City of Rohnert Park Planning Commission Report

STUDY SESSION - PLSU17-0003 Conditional Use Permit and Site

Plan and Architectural Review for a Krispy Kreme Doughnut Facility

5090 Redwood Drive APN 045-083-001

Figure 3 Floor plan

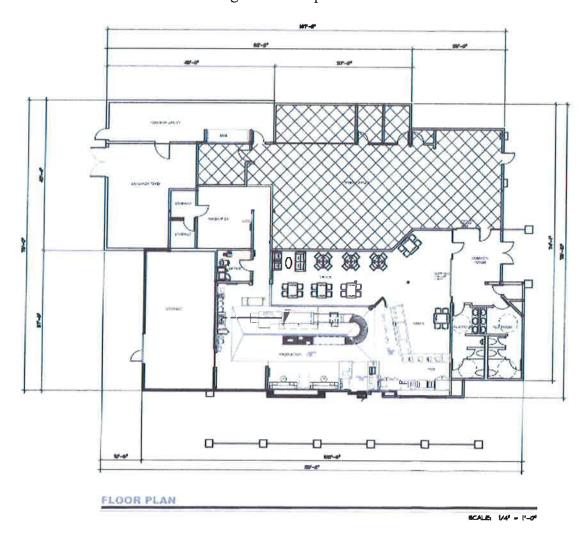
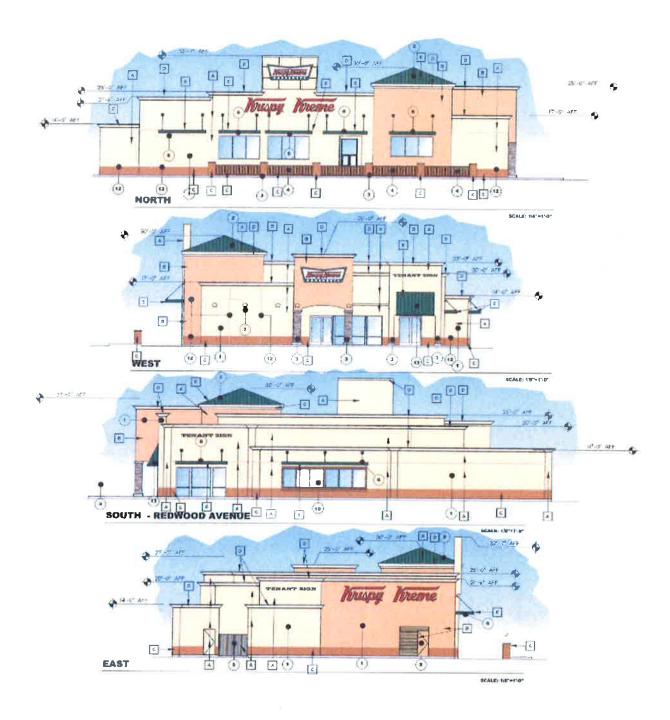
<u>Floor Plan</u>- There is a common foyer entrance to the building serving both tenants. The customer serving and seating for Kristy Kreme customers is relatively small compared to the area they will occupy in the building. The majority of the Kristy Kreme occupancy is devoted to food preparation, storage, utilities and an exterior yard with refuse containers. The storage and exterior yard area are accessible from a driveway that is separate from the main driveway to the property. The use of these areas will therefore not interfere with customer parking or the drivethru.
